SAFETY EVALUATION BY THE OFFICE OF NUCLEAR REACTOR REGULATION
RELAXATION REQUEST FROM ORDER EA-03-009 REGARDING THE
EXAMINATION COVERAGE FOR REACTOR PRESSURE VESSEL HEAD
INCORE INSTRUMENTATION PENETRATION NOZZLES
FACILITY OPERATING LICENSE NO. NPF-6
ENTERGY OPERATIONS, INC.
ARKANSAS NUCLEAR ONE, UNIT 2
DOCKET NO. 50-368

2.0 RELAXATION REQUEST FROM EXAMINATION COVERAGE FOR RPV HEAD ICI PENETRATION NOZZLES, ORDER EA-03-009

Figure 1

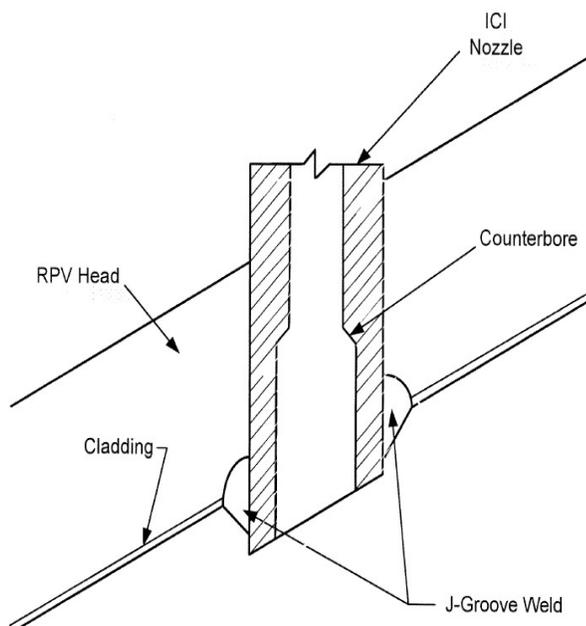
The licensee states that the ICI nozzles are manufactured with a counterbore above the J-groove weld (Figure 1). According to the licensee, because of UT transducer liftoff of at the counterbore, a UT blind zone exists at the upper hillside location (180° azimuth) of each ICI nozzle. The licensee describes the dimensions of the blind zone as measuring approximately 0.88 inch in axial length, with the bottom of the blind zone located 1.080 inches above the top of the J-groove weld. The licensee states that the portion of the counterbore blind zone that lies within the required inspection zone of 2-inches above the J-groove weld is centered at the upper hillside location of each nozzle, and has a circumferential extent of 82°. According to the licensee, the blind zone associated with the counterbore does not exist at any other azimuthal location along the circumference of the ICI nozzle within the required 2 inch inspection area above the J-groove weld. The licensee states that the counterbore is significantly closer to the J-groove weld on the upper hillside of the nozzle than on the lower hillside, due to the RPV head angle at the ICI locations. The licensee also states that no volumetric inspection equipment is available to inspect the counterbore region, and resolving the UT limitations due to the counterbore would require eliminating the counterbore region through a physical modification of the nozzle itself. Entergy further states that it does not have the equipment necessary to perform such a modification.

The ICI nozzles differ from CEDM nozzles by having a counterbore with an axial length of 0.25 inch and a taper of 1 to 4 (radial depth to length), located at 1.080 inch from the top of the J-groove weld. The blind zone is caused by the lift-off of the UT transducer sled over the

counterbore during scanning. Since the licensee did not model the counterbore region with a mesh size that could account for stress increases, the staff requested the licensee to provide an error assessment. In response to the NRC staff's concern, the licensee provided additional information in its letter of September 26, 2003, which is based on additional FEM analyses on nozzles with and without a counterbore, where an adequate mesh was used for the counterbore region. The results indicate that the maximum axial stresses increase by 25% to 30%, while the hoop stresses stay approximately the same. The NRC staff considers this finding reasonable because geometric discontinuity is only seen in the axial direction of the ICI nozzle with a counterbore, not the circumferential direction. The NRC staff addresses the significance of the higher axial stresses in its evaluation of the licensee's fracture mechanics analysis, as described below. With the stress issue specific to ICI nozzles addressed appropriately by the licensee, the staff finds that the FEM modeling for the ICI nozzles is adequate, and the resulting stresses can be used as input to the licensee's fracture mechanics evaluation.

The NRC staff finds that the licensee's proposed alternative examination of the ICI RPV head penetration nozzles, including its crack growth analysis to justify not inspecting the blind zone in the counterbore region, provides reasonable assurance of structural integrity of the RPV head, VHP nozzles, and welds. Further inspection of the ICI nozzle counterbore region in accordance with Section IV.C.(1)(b)(i) of Order EA-03-009 would result in hardship without a compensating increase in the level of quality and safety.

Figure 2

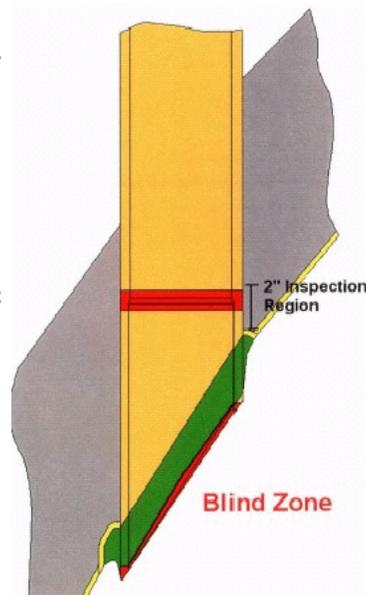
The licensee stated that it will perform a UT examination from the inside diameter (ID) of each ICI nozzle (i.e., nozzle base material) in accordance with Section IV.C(1)(b)(i) of the Order, with the exception of the blind zone at the bottom of each ICI nozzle, and the blind zone in the counterbore region above the J-groove weld of each ICI nozzle. For illustration purposes, Figure 1 shows the ICI nozzle configuration, and Figure 2 shows the location of the blind zones. Figure 1 was taken from the licensee's September 24, 2003, letter, and Figure 2 was taken from the licensee's presentation that it gave at NRC headquarters on August 14, 2003.
